From:Todd HoffmanTo:MCP-ChairSubject:Town of Chevy Chase Testimony re. LMA H-148 (Item 5; March 9, 2023)Date:Wednesday, March 8, 2023 9:42:11 AMAttachments:TOCC Testimony re. LMA H-148 (3-9-23).pdf

Todd Hoffman Town Manager Town of Chevy Chase, Maryland <u>4301 Willow Lane</u> <u>Chevy Chase, MD 20815</u> <u>301-654-7144</u> (P) <u>301-718-9631</u> (F) thoffman@townofchevychase.org Testimony of Town of Chevy Chase, Maryland Montgomery County Planning Board Public Hearing on LMA H-148 March 9, 2023

SECTION 3 OF THE VILLAGE OF CHEVY CHASE

MD 185 (Connecticut Ave) at Taylor St – Signal Design Concept – Split Phase Alternative 1

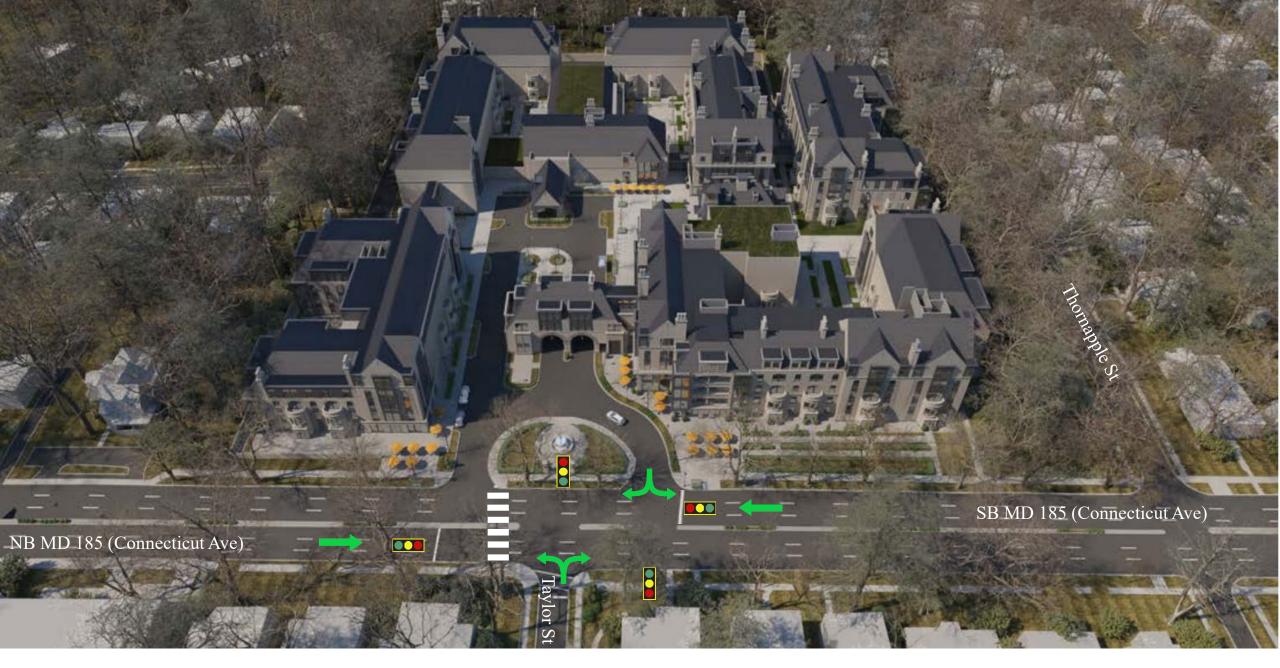
We would like the traffic study to include among other things: the impact on traffic and pedestrian safety if the configuration of entry and exits, crosswalk and breaks in the median strip are retained as they are now; ways to preclude increased cut-through traffic on Taylor St. across from Corso; and finally, we would like the study to evaluate some possible creative alternatives provided by a traffic engineer at the State Highway administration (attached) that might address our concerns about public safety and cut-through traffic in our community. Ultimately, we would like to see the study recommend the safest solution and their justification for that solution.

While we are not traffic engineers, it is clear to us that the status quo will lead to illegal, dangerous U-Turns resulting in backups at best and accidents at worst—in short, unsafe conditions for both vehicles and pedestrians.
